TO: All Weil-McLain Distributors and Agents
FROM: Mike Boyd - Product Marketing Manager
SUBJECT: Updated U-Control Software on Ultra Gas Series 3 Boilers

5 WAYS TO IDENTIFY IF AN ULTRA GAS SERIES 3 BOILER IS PROGRAMMED WITH THE LATEST SOFTWARE (Control V1.04, Display V1.03 - Rolling Change Released 10/08)

3. DATE CODE

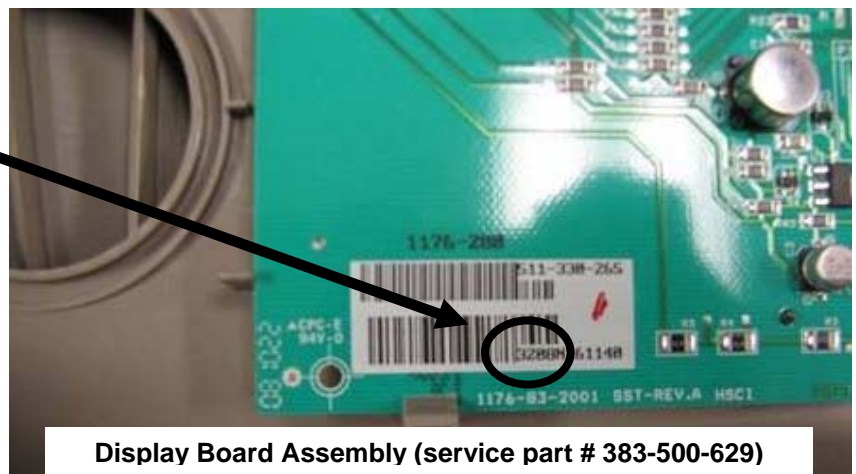
(On both the module & display part)

Updated software date code-
first four digits 4008 or higher

Original software date code-
first four digits 3908 or lower
